Construction Traffic Management Plan

Artarmon Substation Site Operations

Line-Wide Works Contract Sydney Metro City & Southwest

Project number:	C600
Document number:	SMCSWLWC-SYC-ATS-TF-PLN-002690
Revision date:	28 February 2020
Revision:	0

Figure 6 – Vehicle movements forecast

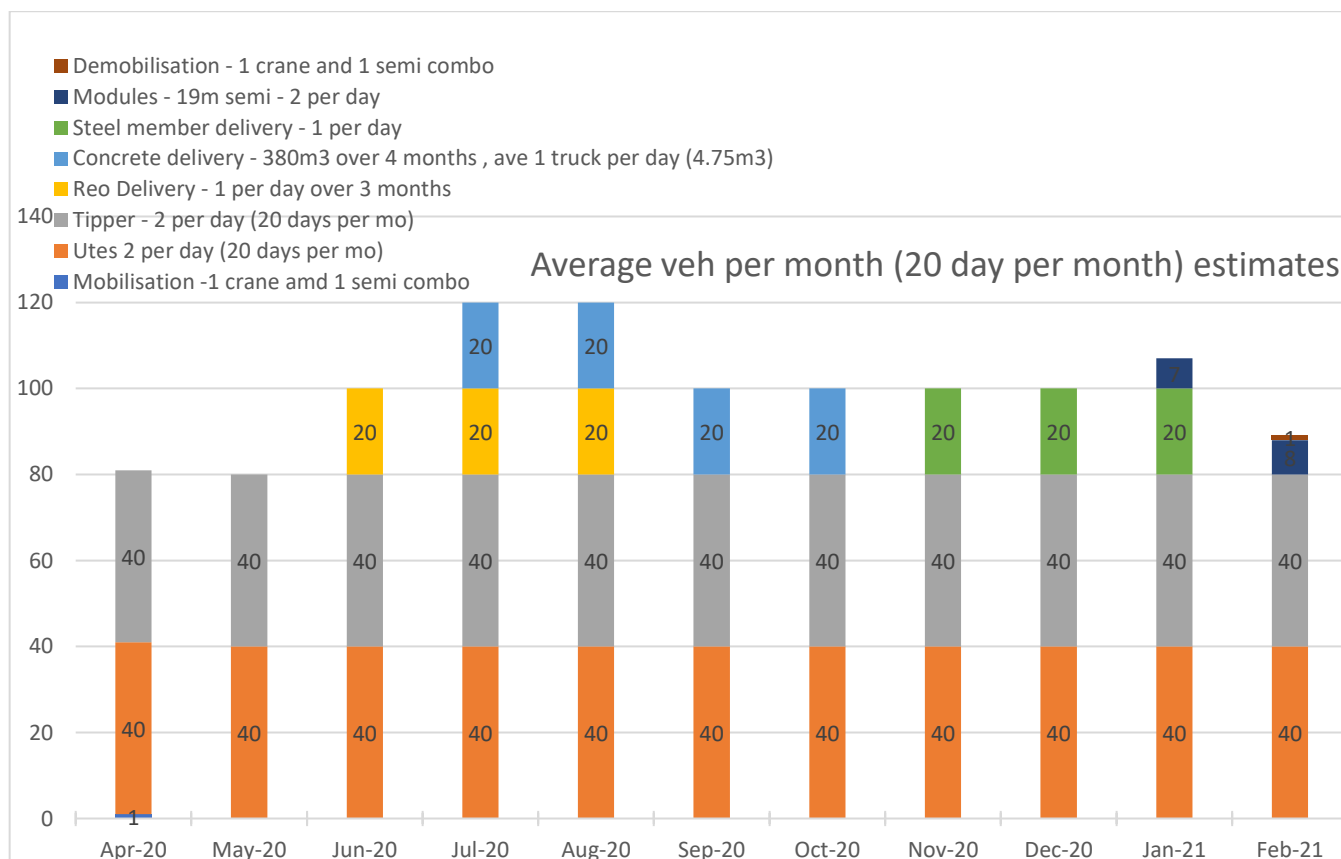
Revision	Details
A	Issued to TTLG for stakeholder review.
B	Revision per comments from CTMP review process. Figure 3 updated with latest model. Figure 6 added. Design drawings updated in Appendix A with the latest design. General update to the TCPs.
C	Additional Metro's comment. Clarification to Fig.6 and traffic control at Whiting St.
0	RMS approval.

Appendix C. TCPs, Construction routes, Vehicle Movements

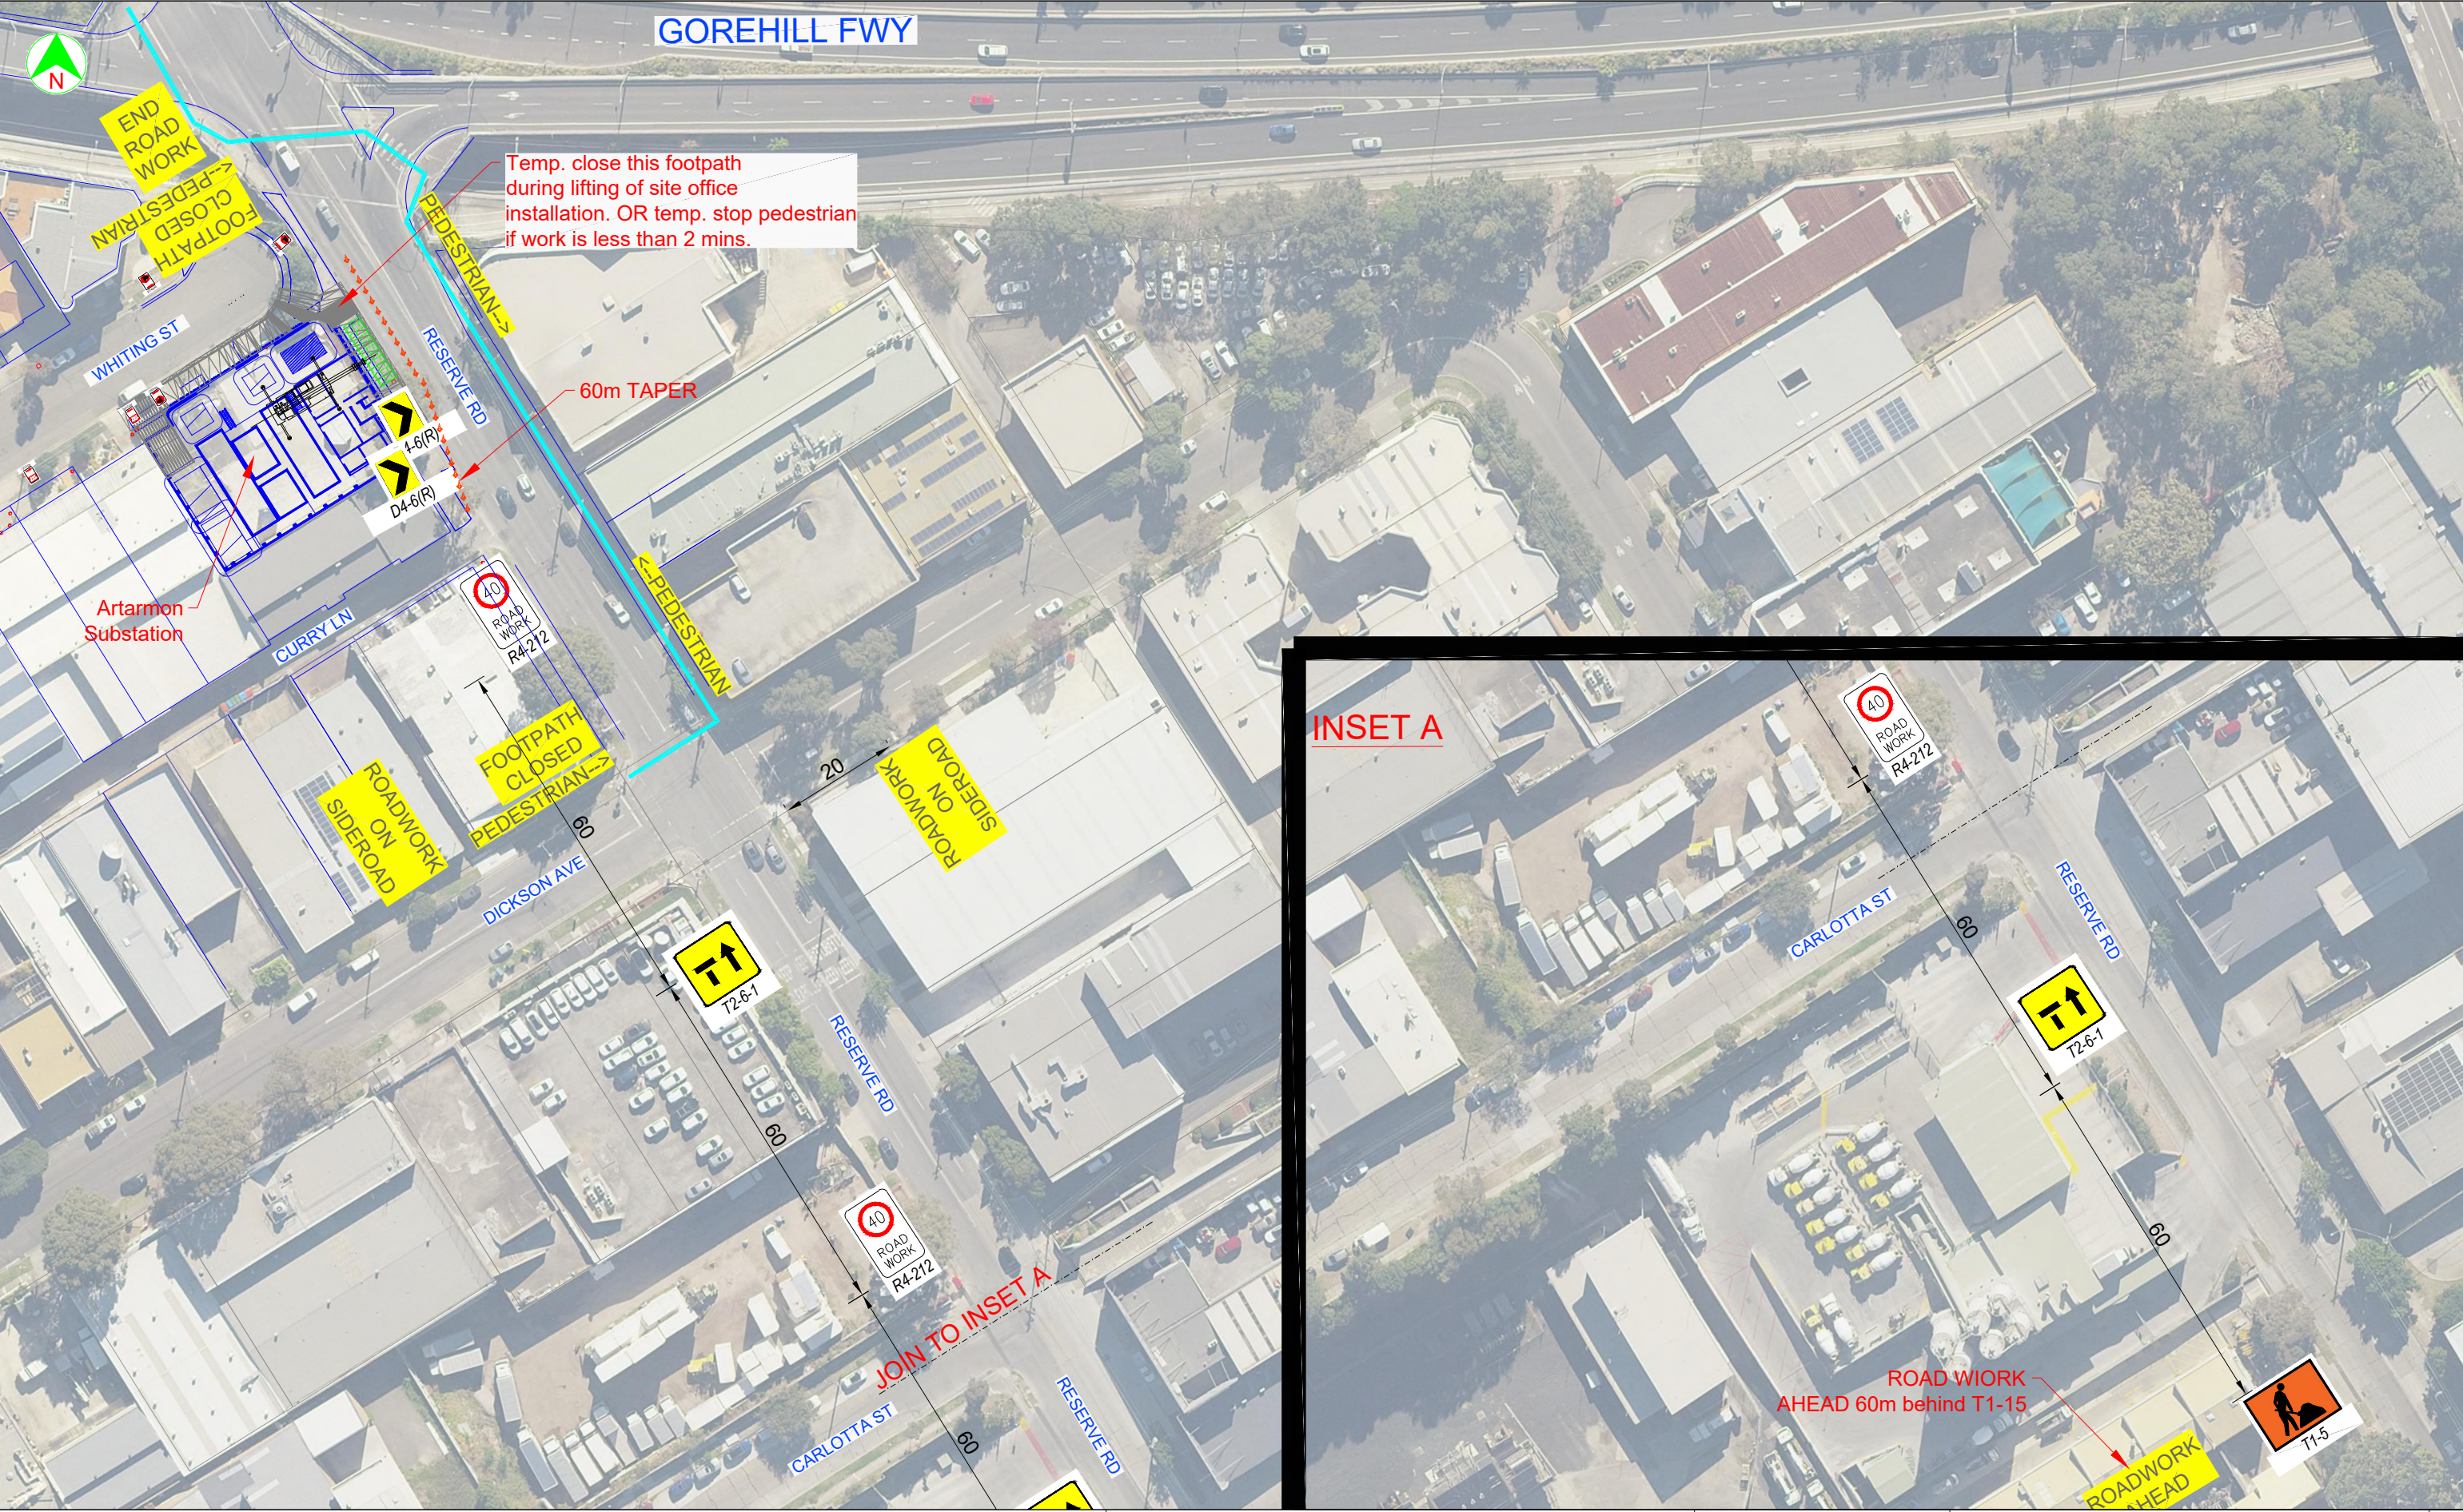
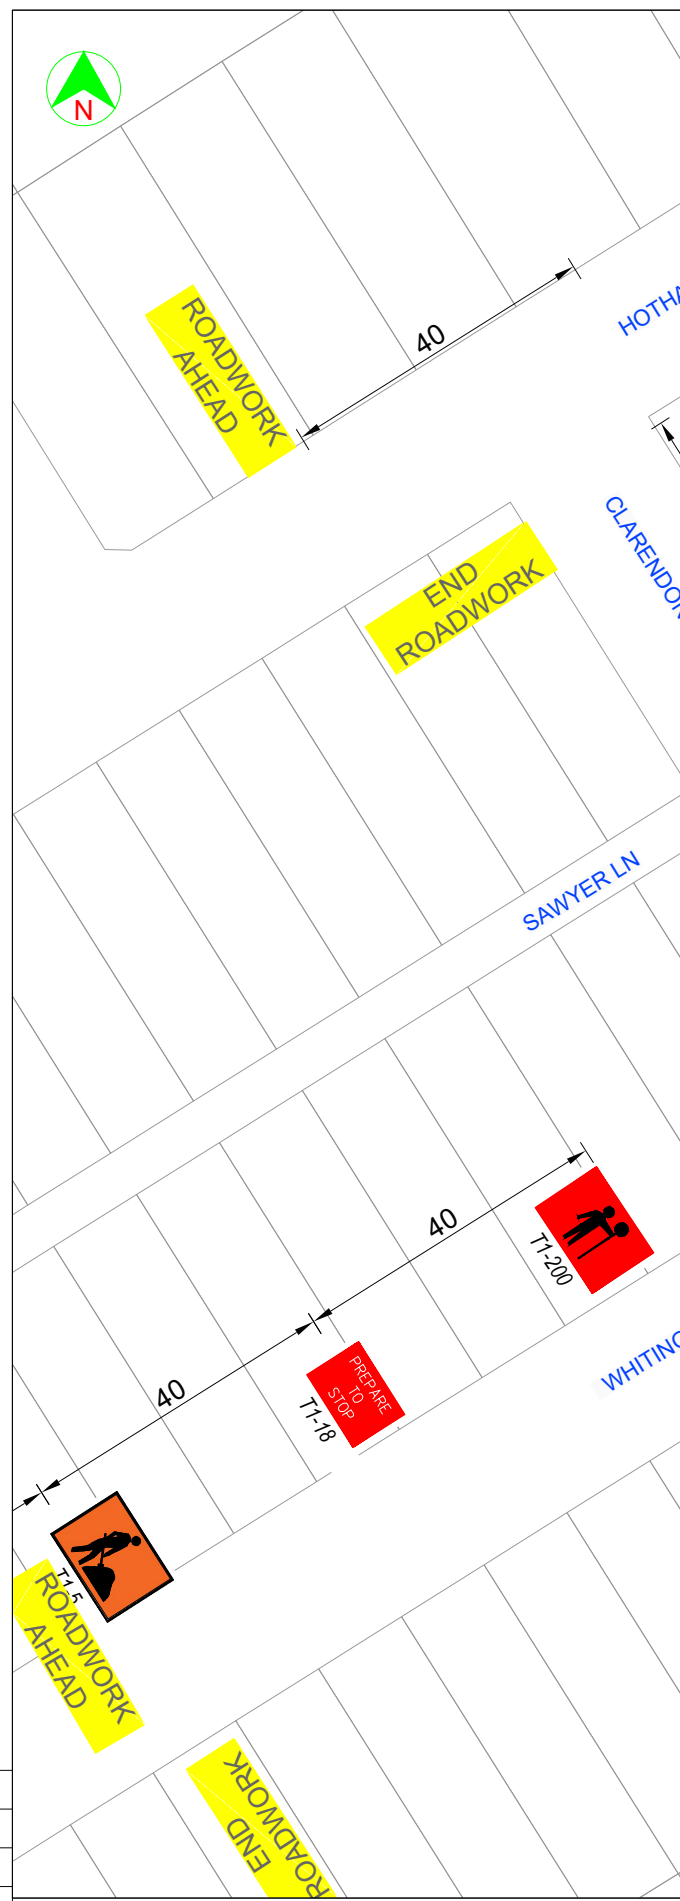
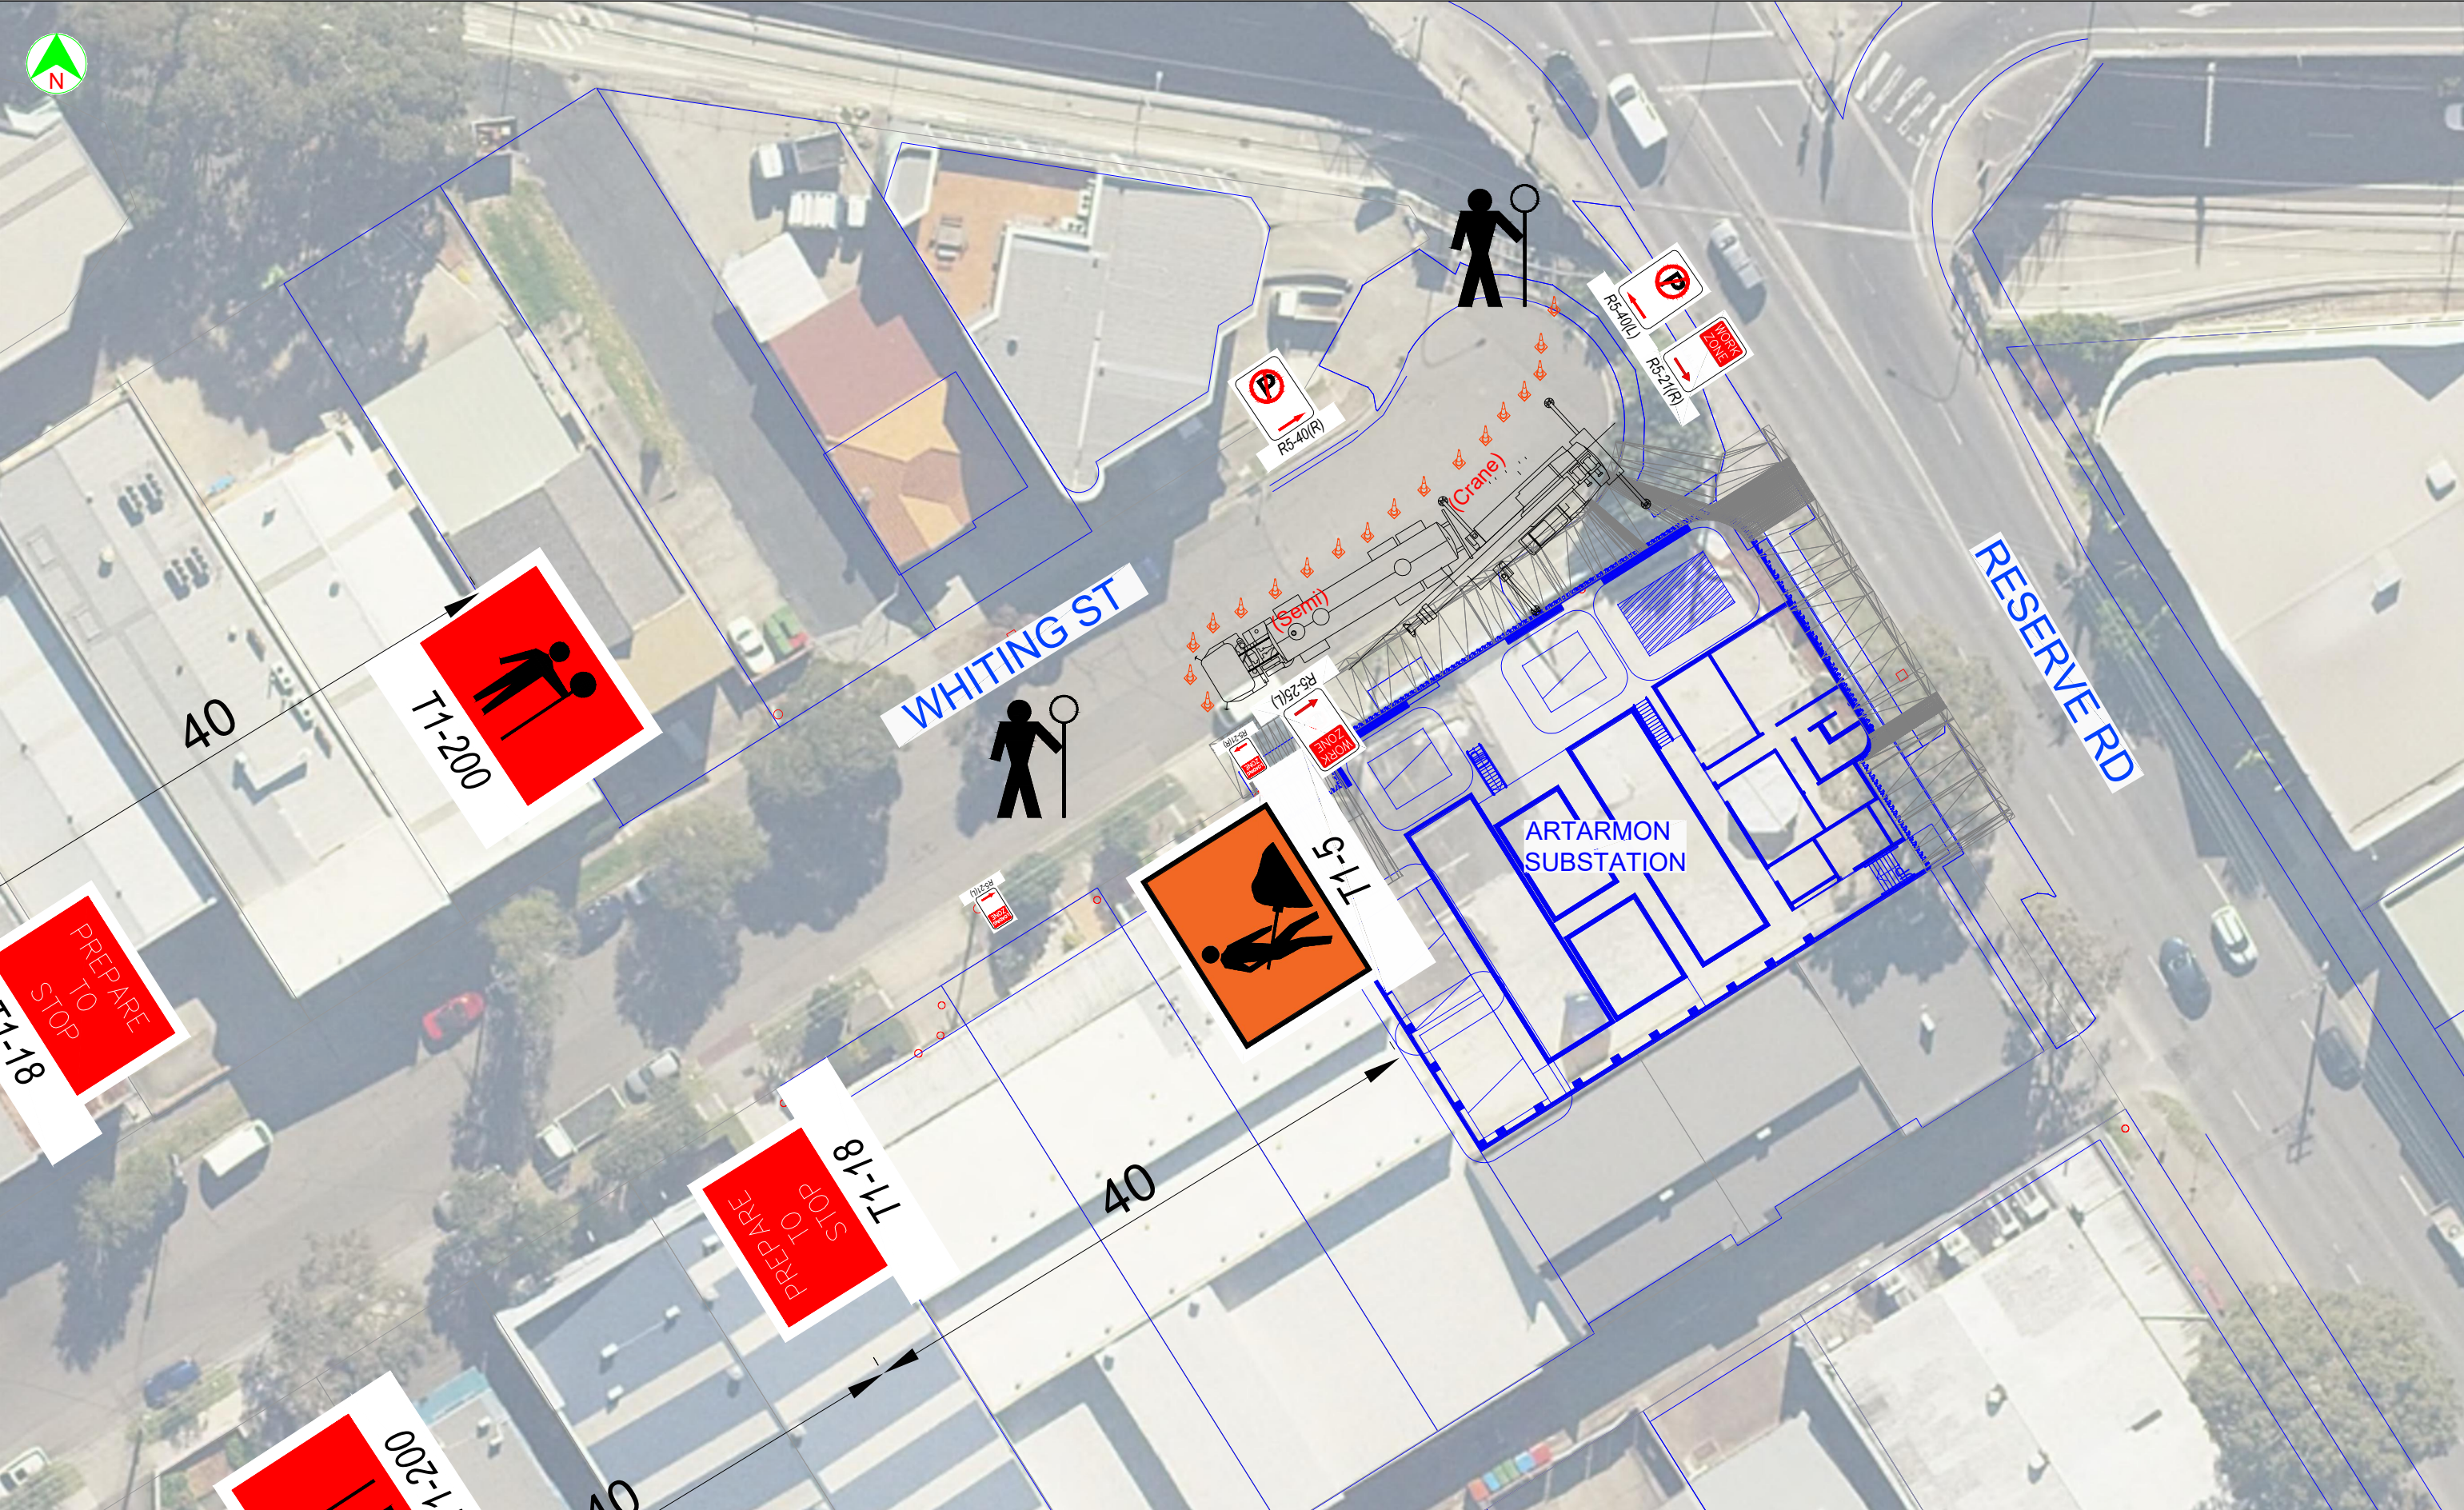
22	14/01/2020	SCO	S Brown	SMCSWLWC-SYC-ATS-TF-PLN-002690	Appendix C		The locations of Traffic Controllers should be shown in more detail. It appears there is no Traffic Controller situated on Clarendon St, north of Whiting St	TCPs updated similar to comments # 9.			rev A
23	4/02/2020	SM	K Hind	SMCSWLWC-SYC-ATS-TF-PLN-002690 Rev : B	Figure 6		The delivery volumes shown grey and dark orange are not included in the legend. What do these volumes refer to?	These were the 1 movement each for the compound mobilisation and demobilisation. The legend was hidden due to the chart size margin. Figure 6 is revised with the missing legend. Movement include a mobile crane and a flatbed truck to carry the site office.			rev B
24	4/02/2020	SM	K Hind	SMCSWLWC-SYC-ATS-TF-PLN-002690 Rev : B	Section 5		Sydney Metro contacts: Should be Phil Brogan / Ken Hind	(Phil B and Ken H was already on the list from previous rev). No action required.			rev B
